RIDGWAY PLANNING COMMISSION

REGULAR MEETING AGENDA

To: Town of Ridgway Planning Commission
Cc: Preston Neill, *Ridgway Town Manager*
From: TJ Dlubac, AICP, *Community Planning Strategies, Contracted Town Planner*
Date: August 26, 2022
Subject: Four Winds Sketch Plan for August 30th PC Meeting

FOUR WINDS AT RIDGWAY SKETCH PLAN

SP-2
SHEET 2 OF 6

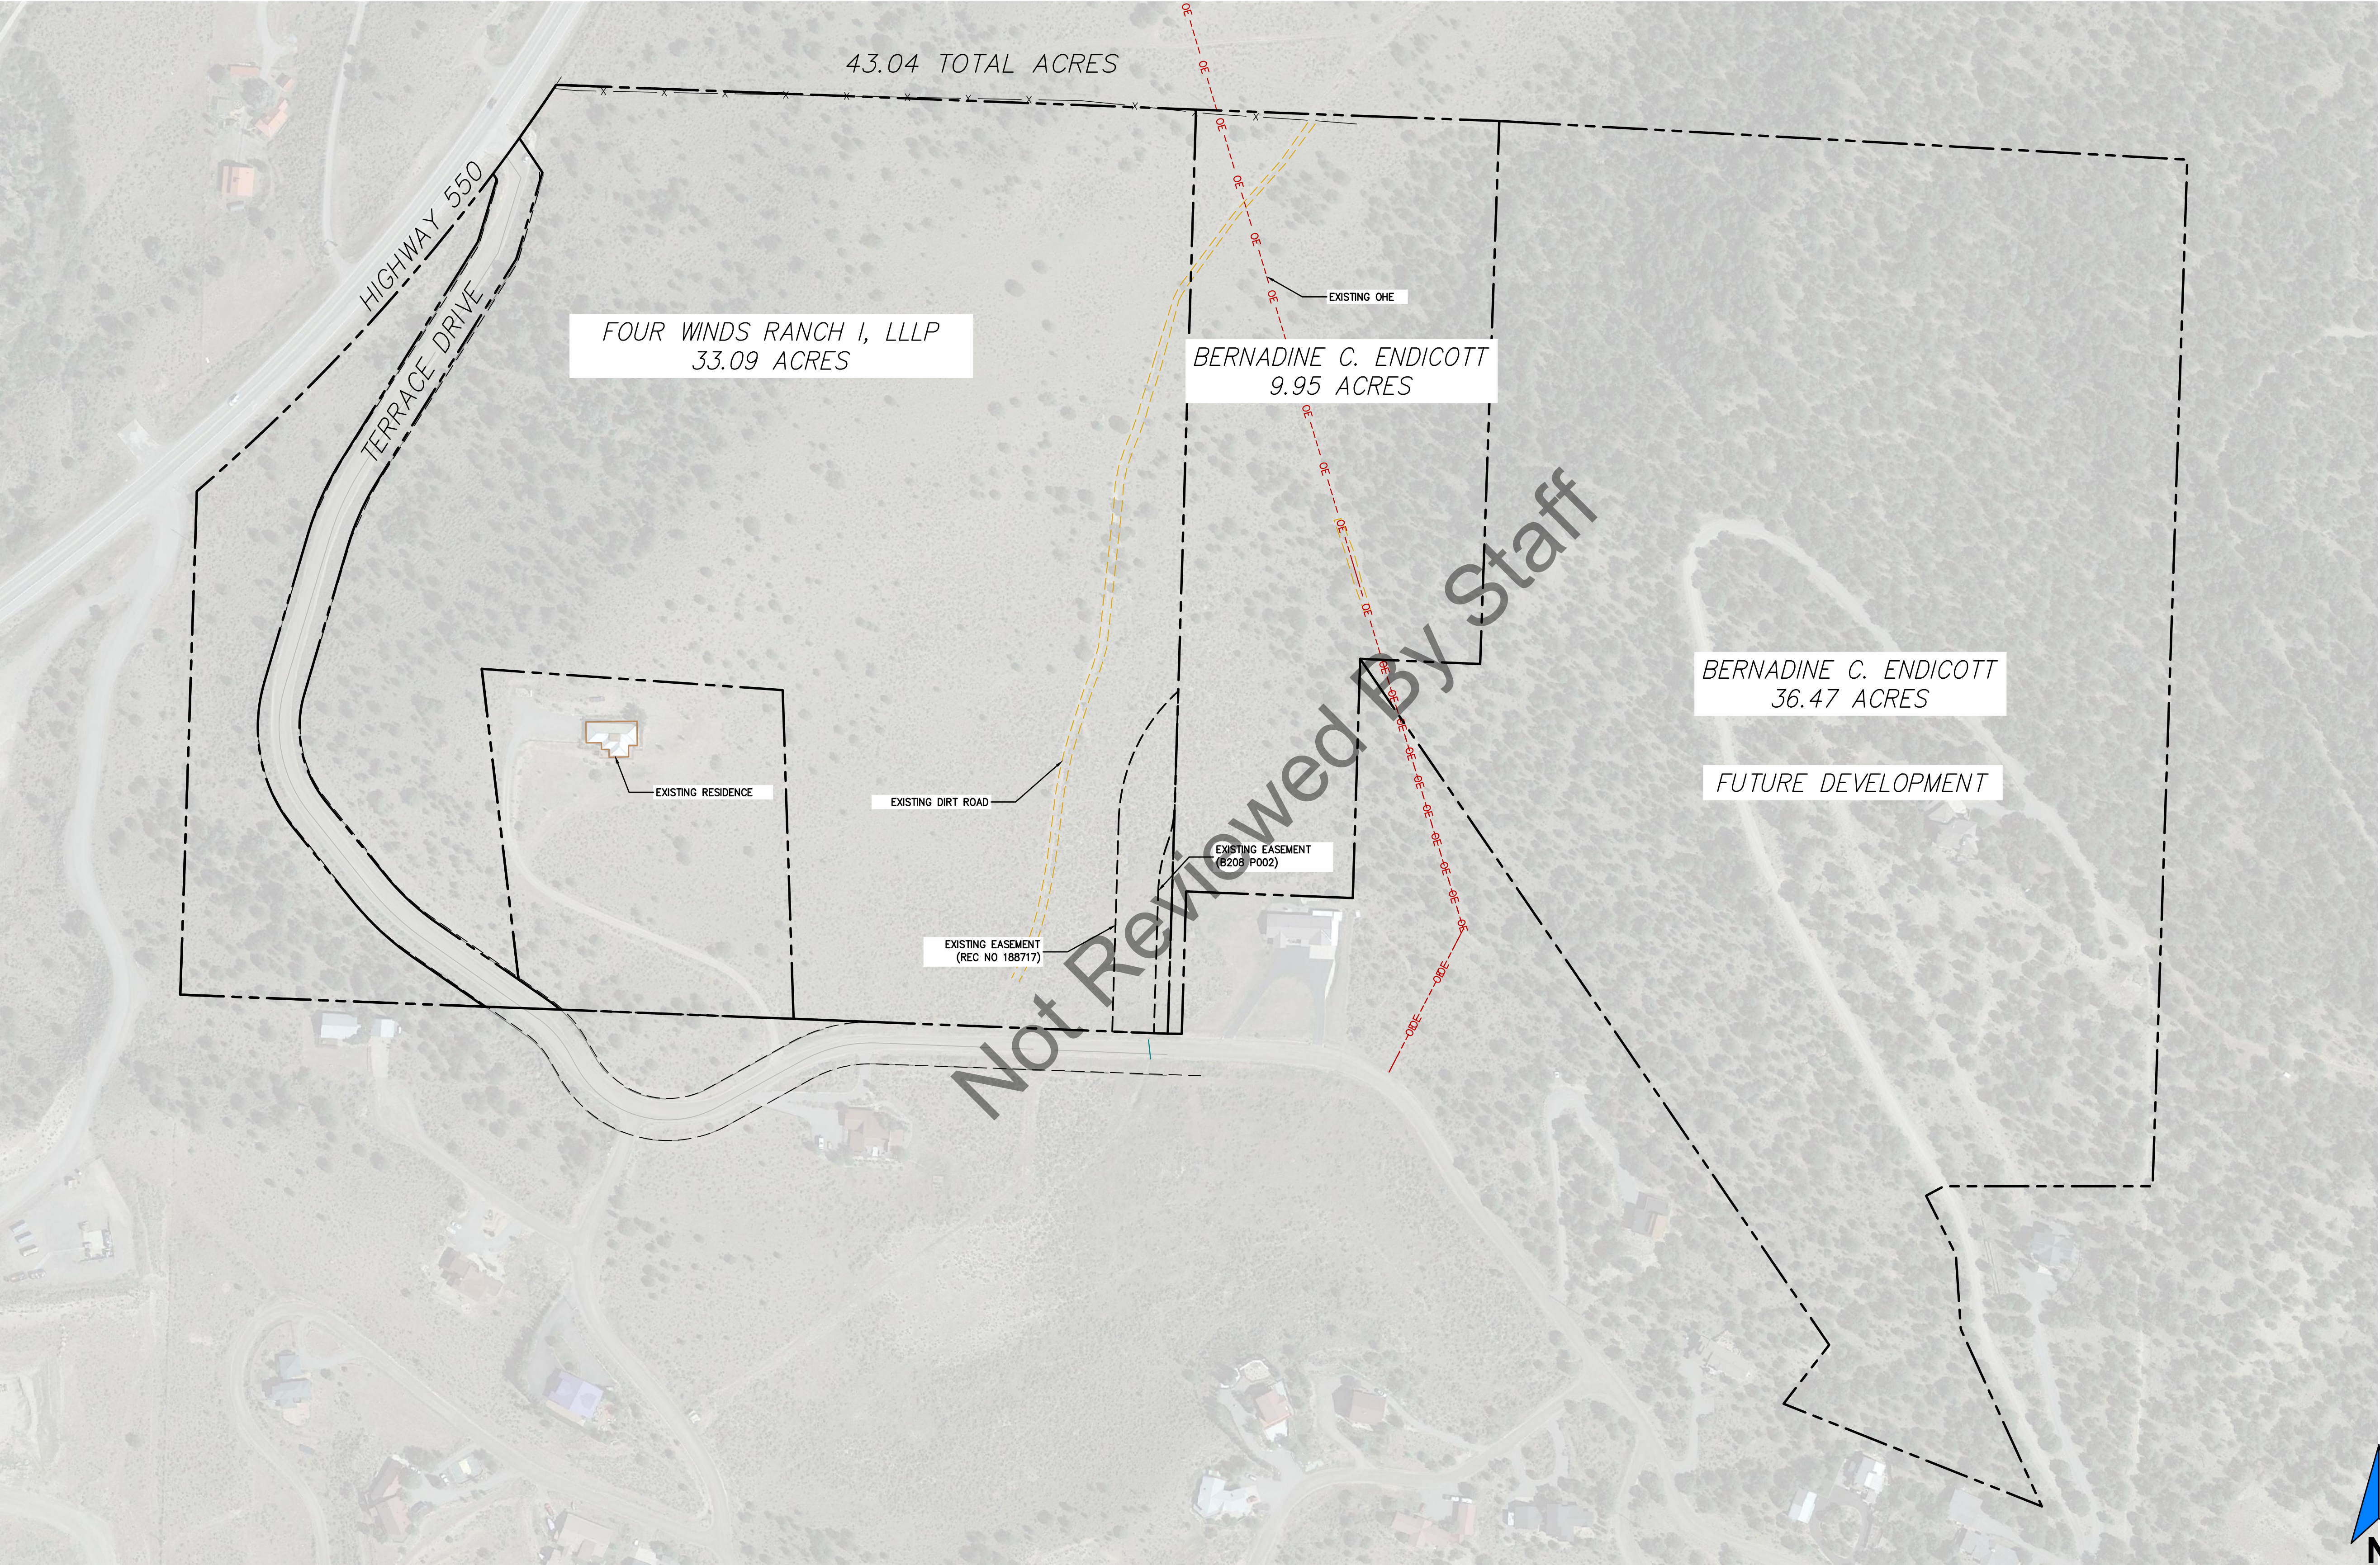
25. Pg 2: Very little of Lots 7, 10 and 14 are shown within the 300 ft radius of a fire hydrant. This hydrant layout is a bit different from the original sketch plan. Is this revised version the correct version? A new hydrant was added to capture Lot 14. Please refer to Sheet SP-5.

PROJECT	2022-018-CIV
DATE	04/26/2022
DRAFTER	WL
CHECKED	DCQ
BUCKHORN ENGINEERING	
SHEET	
SP-5	
SHEET 5 OF 6

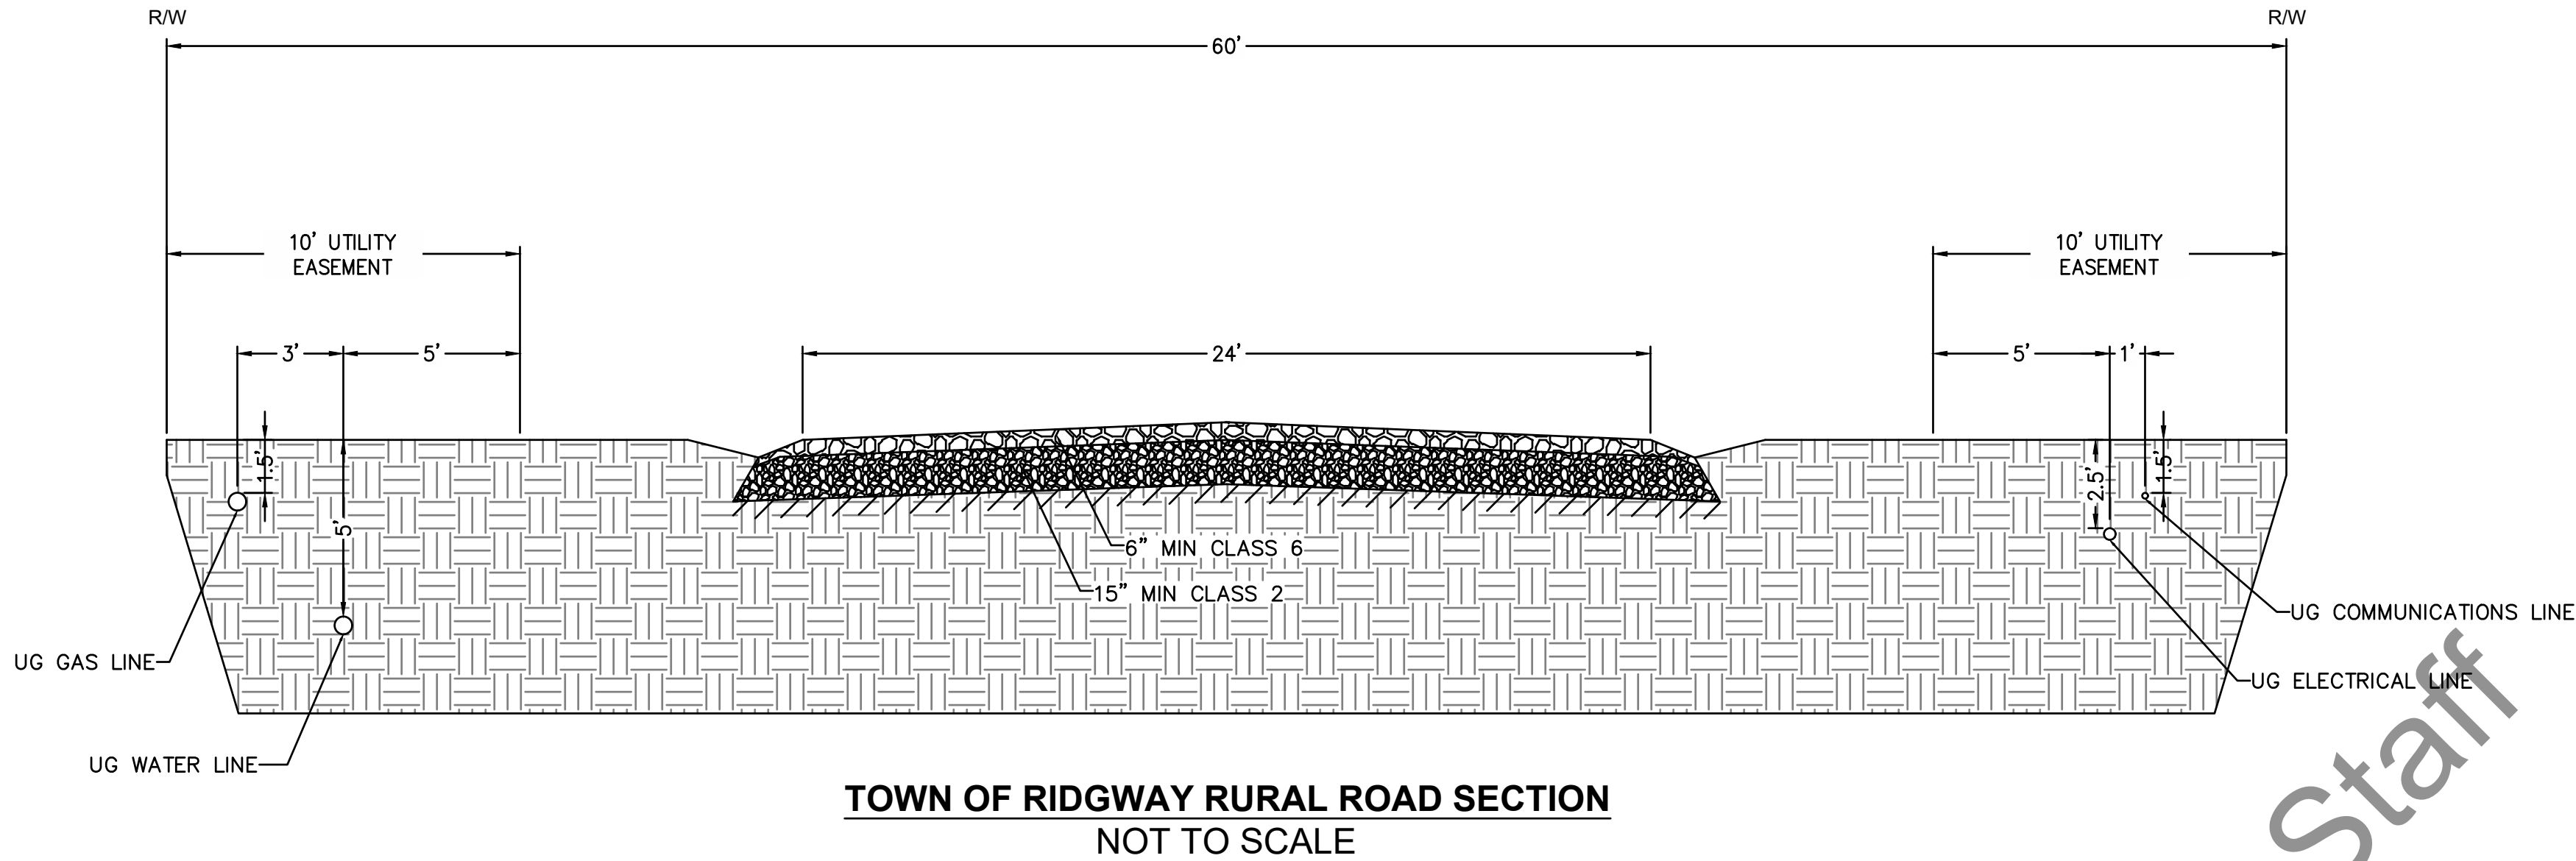
4. Consider requiring wildlife-friendly trash enclosures and measures to reduce conflicts between wildlife and residents. Address this item further with the submittal of the preliminary plat. *Agreed. Please see Note 4 on Sheet SP-5.*

14. The subdivision should have two access points. It was expressed that a second access point was feasible through the Endicott Property earlier in the project, but this is not shown or discussed in the narrative. Either provide a second point of access or provide justification as to why a second access is not feasible in order for staff to adequately evaluate the proposal. *An emergency only access road is now proposed that would utilize the driveway to Lot 14 and then run down the east side of Lots 15 and 16 should the main drive become blocked. Please refer to Sheet SP-5.*

A new emergency access route is now proposed that would utilize the driveway to Lot 14 and then run down the east side of Lots 15 and 16 should the main drive become blocked. Please refer to Sheet SP-5.

WATER TANK SIZING CALCULATIONS

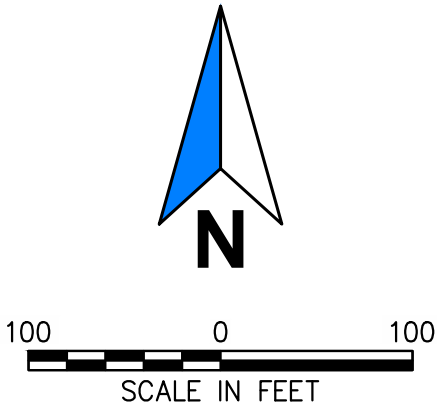
20. Pg 6 of the revised sketch plan shows 10' utility easements within the 60 ft ROW. Those should be on the private property not in Town ROW. ROW does not need easements. *Sheet SP-6 is a copy of the Town specification for Rural Road Section that includes the easements. We agree easements are not needed in a right-of-way.*
